GENESEE COUNTY PLANNING BOARD REFERRALS NOTICE OF FINAL ACTION

T-04-BER-07-24

Site Plan Review and Area Variance for an Approx. 10,640 sq. ft. new commercial retail building (Dollar General) and associated site improvements on vacant land within Apple Tree Acres Business Park.

**RE: NEW 10,640 SF +/- COMMERCIAL RETAIL SPACE
INTERSECTION OF BUFFALO ROAD AND APPLE TREE AVENUE
PRELIMINARY SITE PLAN AND STORMWATER POLLUTION PREVENTION PLAN (SWPPP) REVIEW
MRB GROUP PROJECT NO. 0202.24000.000 – PHASE 007**

TITLE OF DRAWING: SITE PLAN

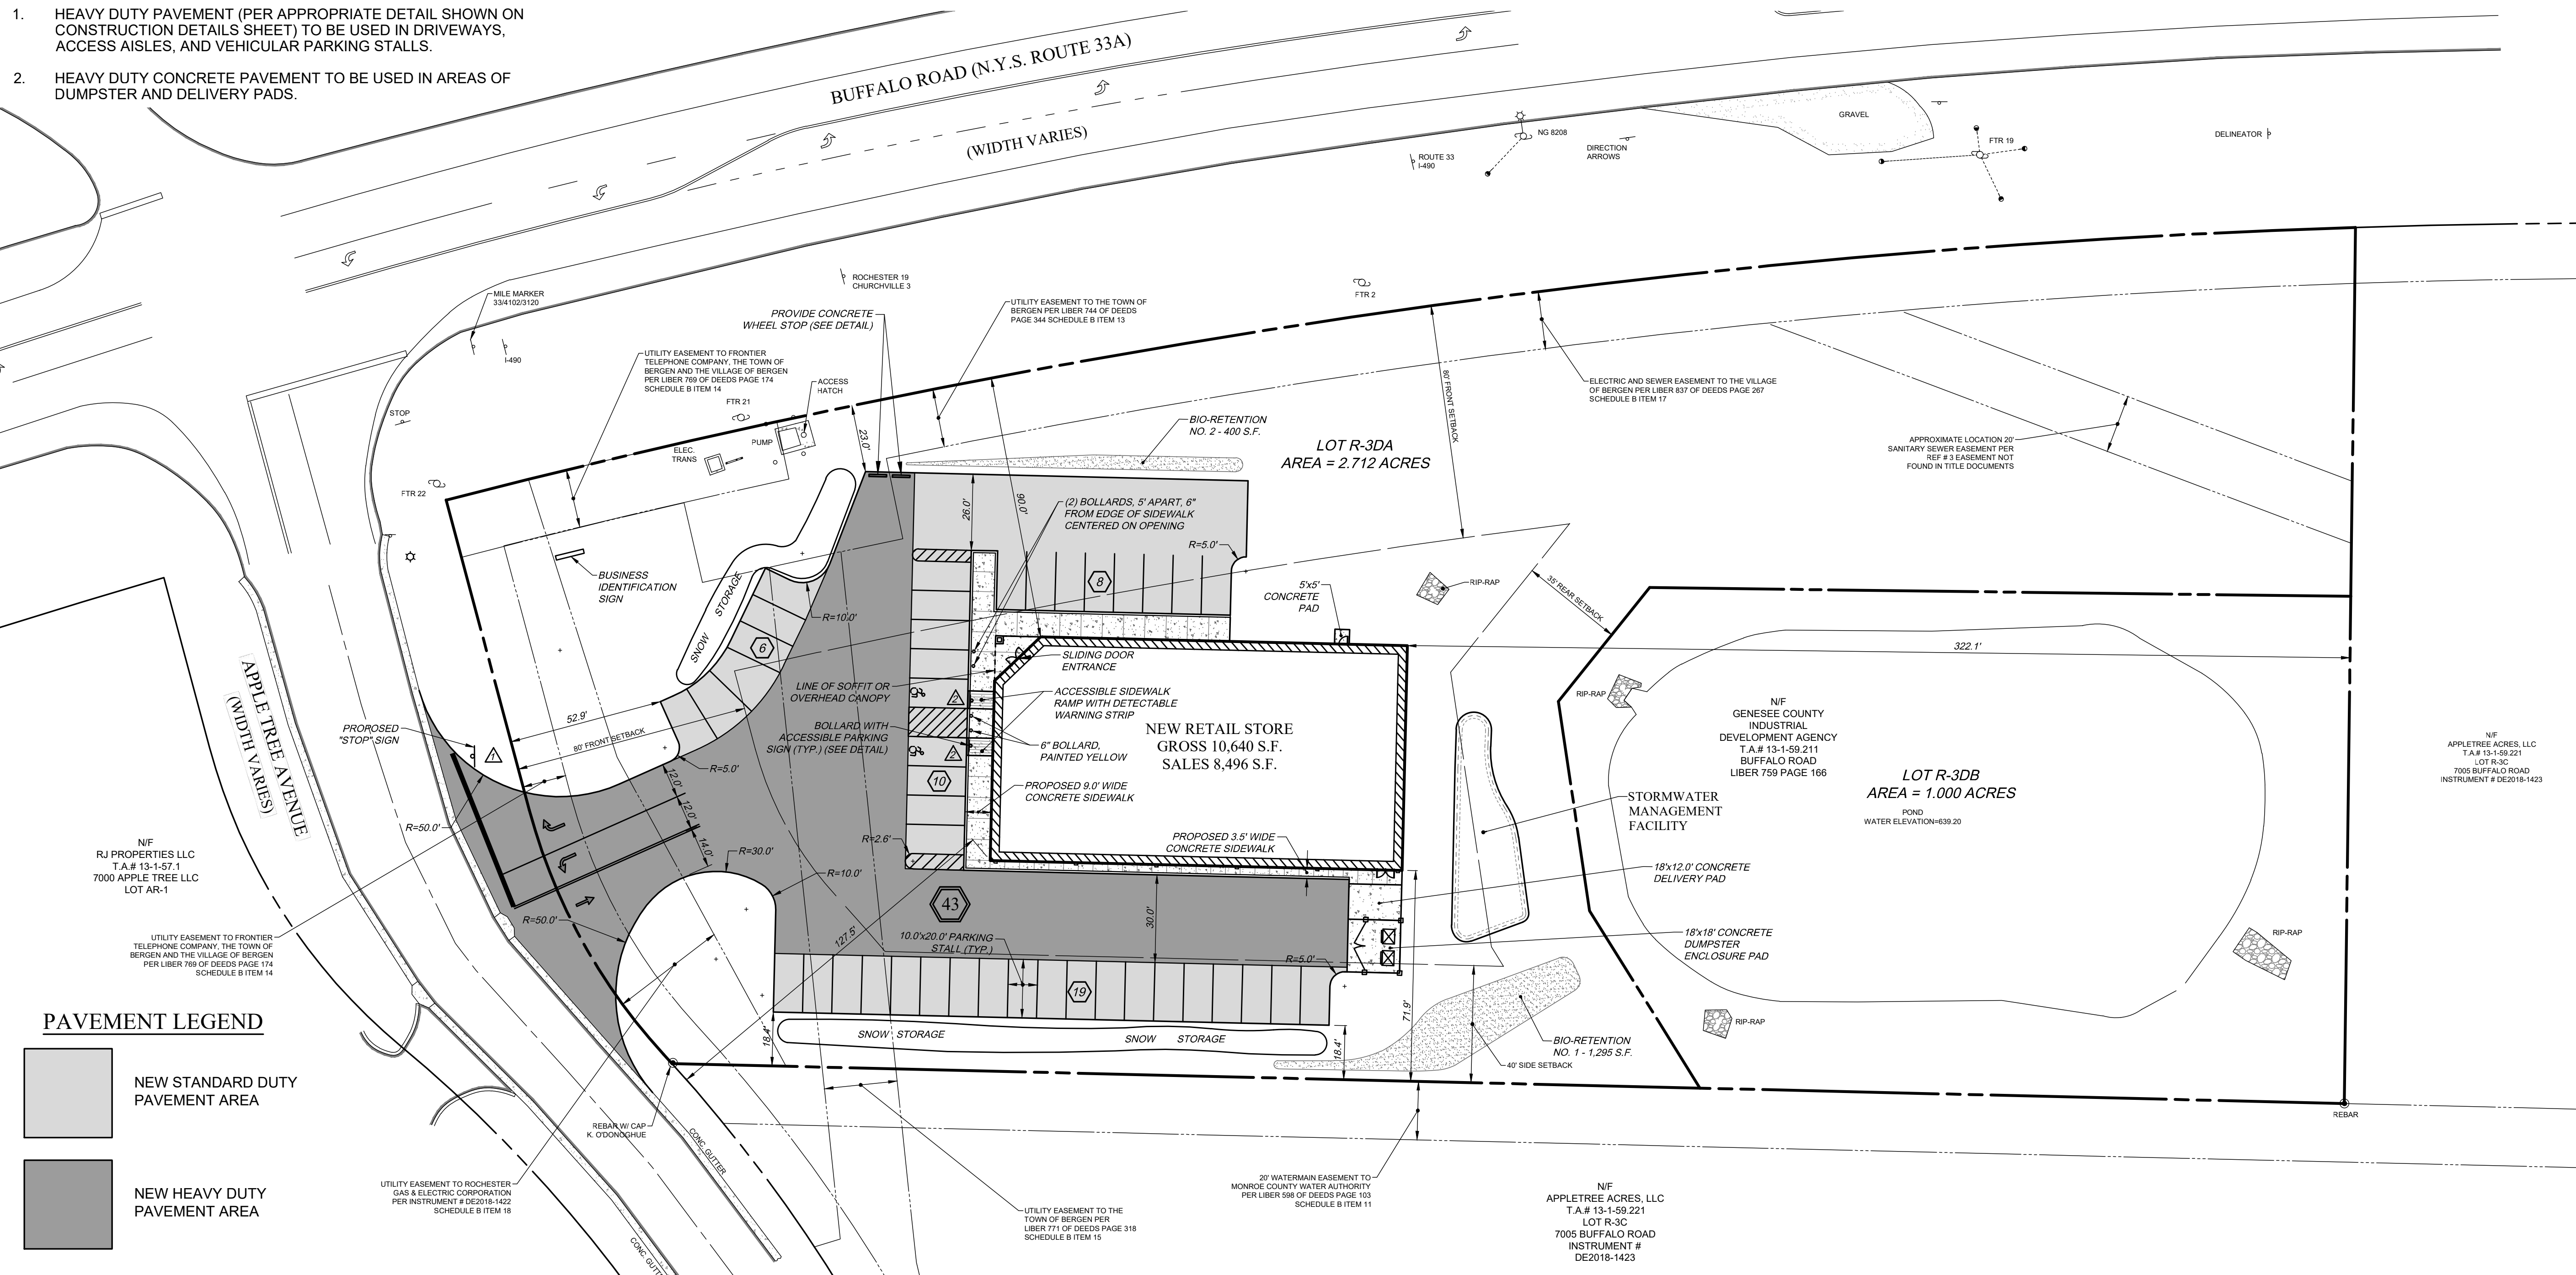
5. The following comments pertain to the Site Plan (Sheet CA110):
 - a. A sequence of construction should be added to the plans. This should include each step of the project clearing, erosion and sediment control measures, grading, stormwater, etc. in chronological order.

- d. The proposed curb cut for ingress/egress is to be reviewed and approved by the Town Highway Superintendent and NYS DOT.
6. The following comments pertain to the Turning Movements Plan (Sheet CE-120):

4. The following comments pertain to the Site Plan (Sheet CA110):
 - a. There currently is a label for "Engineer's Opinion of Earthwork" on the plans but the values are "xxx"; these values should be added to the plan for cut and fill values.

- b. A sequence of construction should be added to the plans. This should include each step of the project clearing, erosion and sediment control measures, grading, stormwater, etc. in chronological order.

- e. The proposed curb cut for ingress/egress is to be reviewed and approved by the Town Highway Superintendent and NYS DOT.
 - f. Any proposed signage such as stop signs (at ingress/egress) should be added to the site plan for review.

WB-67 TRUCK TURNING MOVEMENT IN

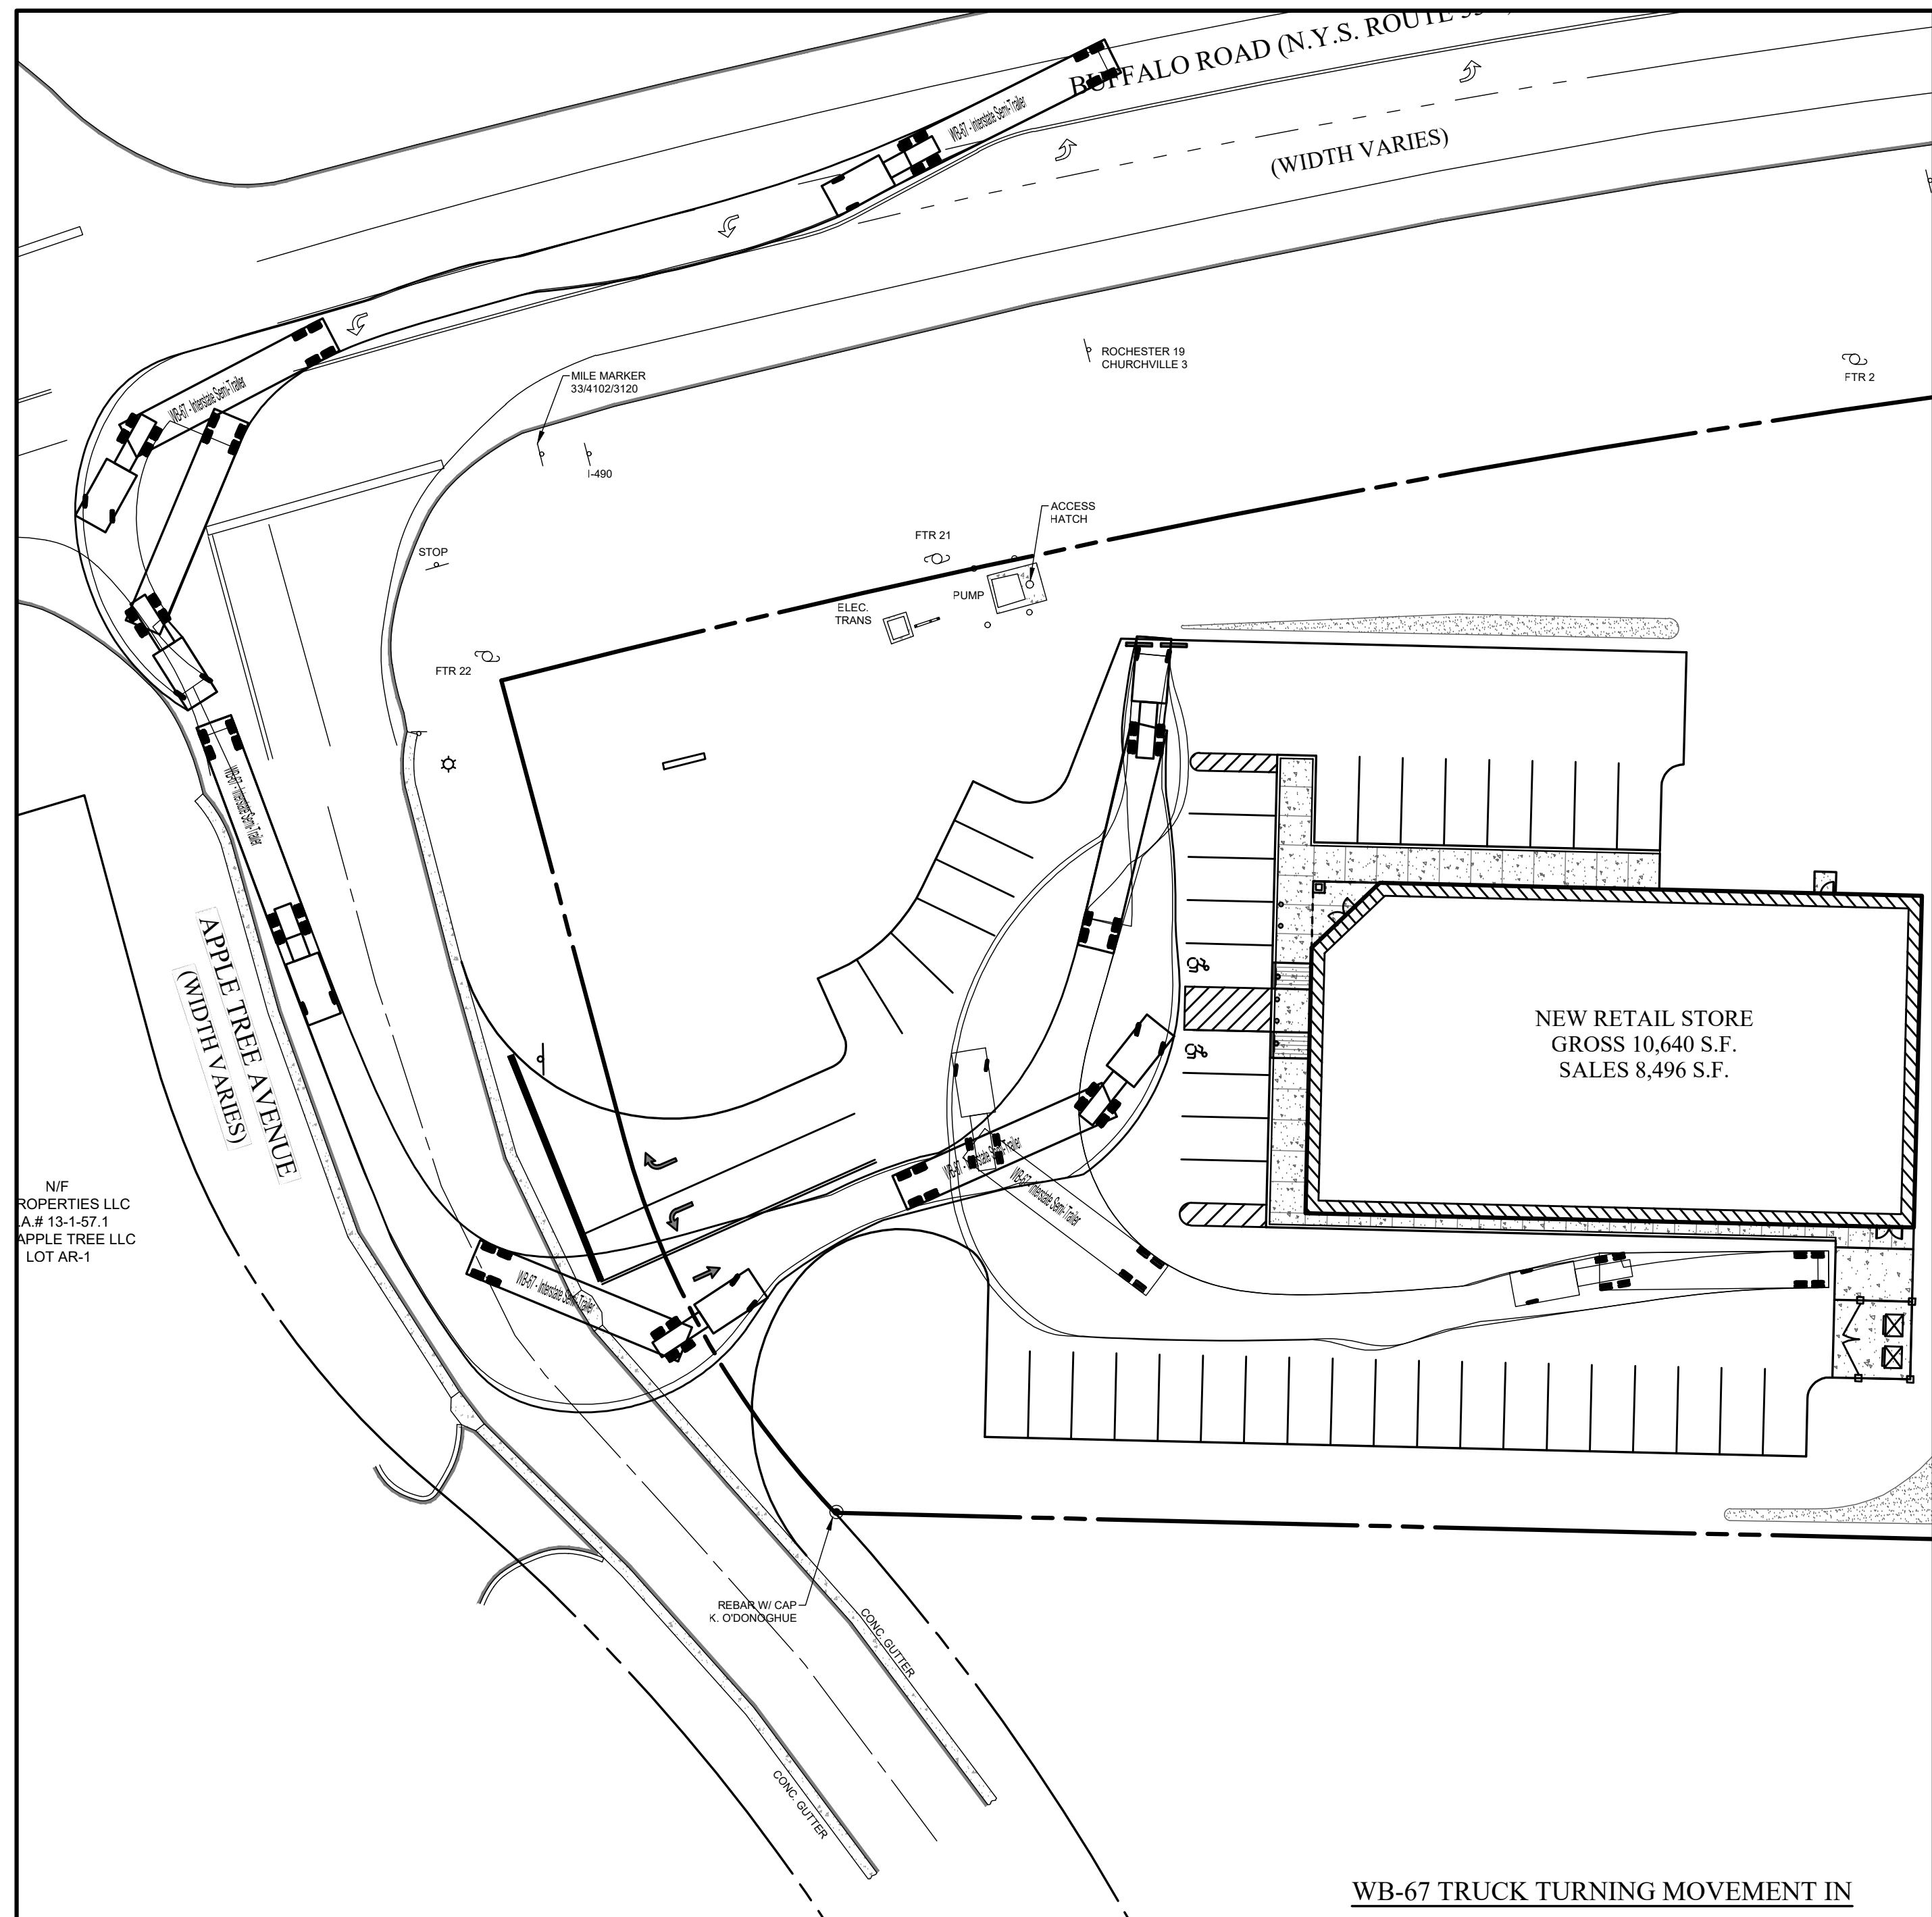
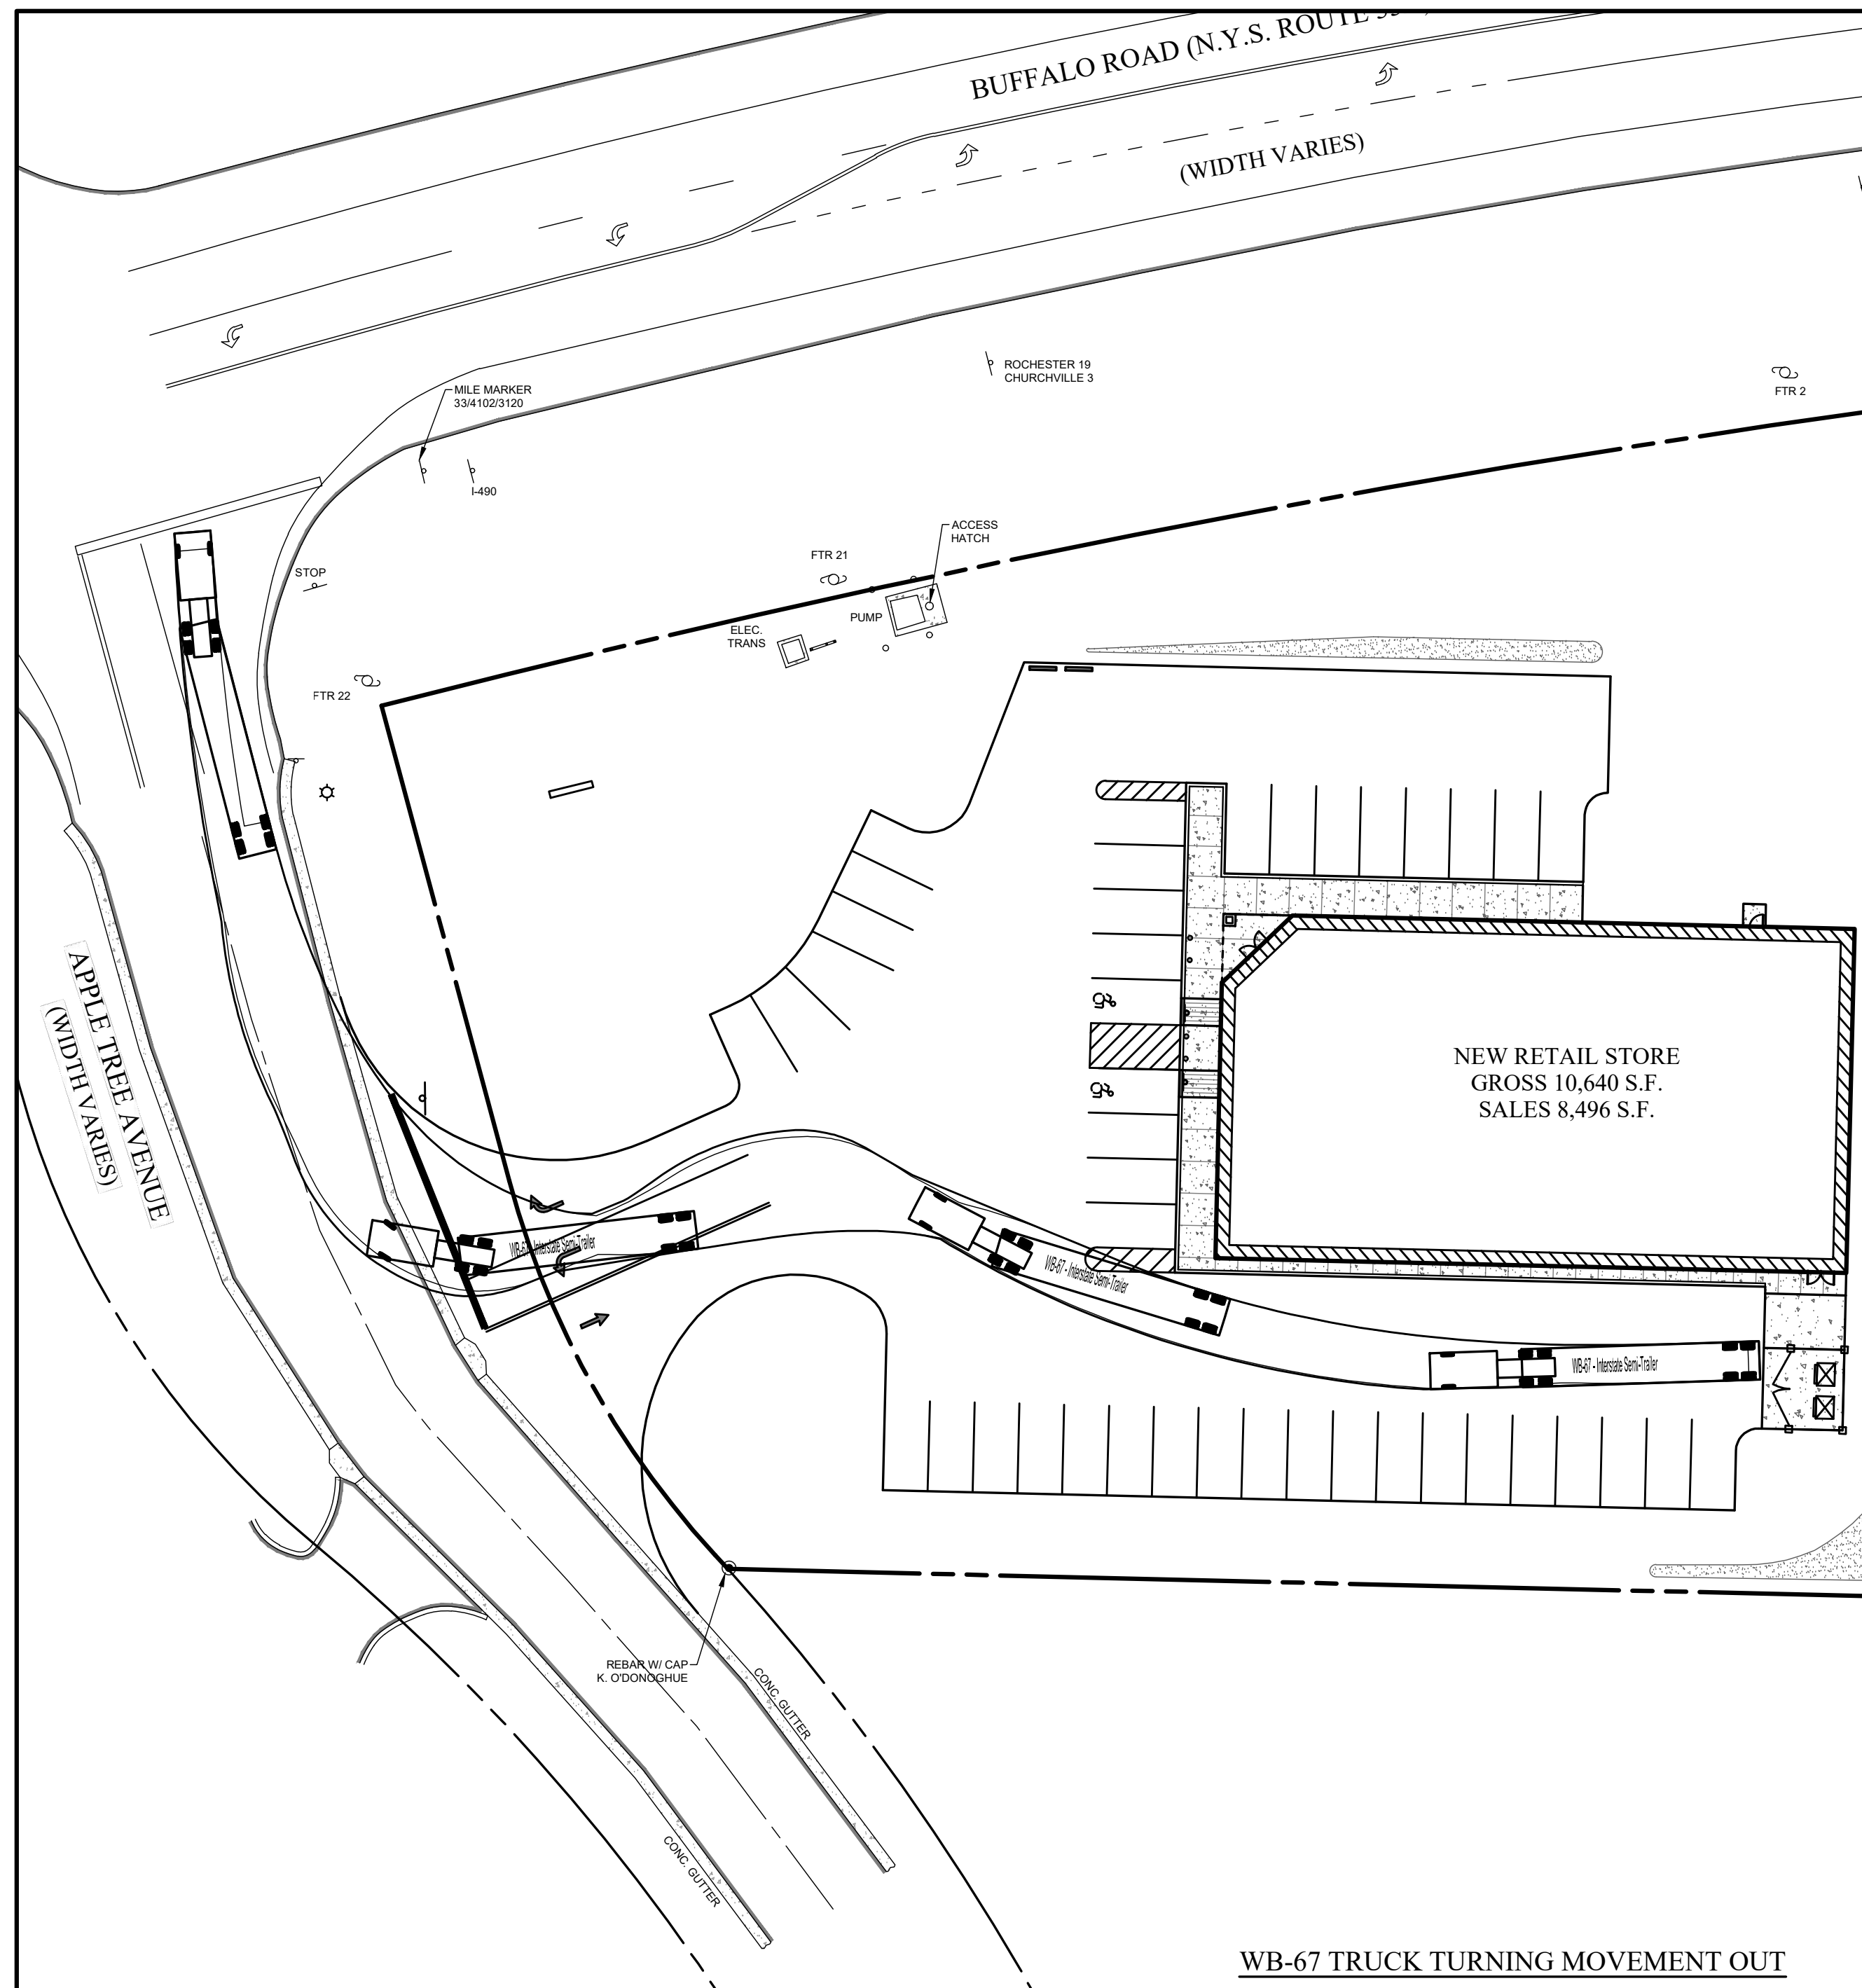
- a. It is recommended that this drawing be completed to show that an emergency vehicle has appropriate clearance for ingress/egress and reviewed/approved by the Fire Marshall.

5. The following comments pertain to the Turning Movements Plan (Sheet CE-120):
 - a. It is recommended that this drawing be completed to show that an emergency vehicle has appropriate clearance for ingress/egress and reviewed/approved by the Fire Marshall.
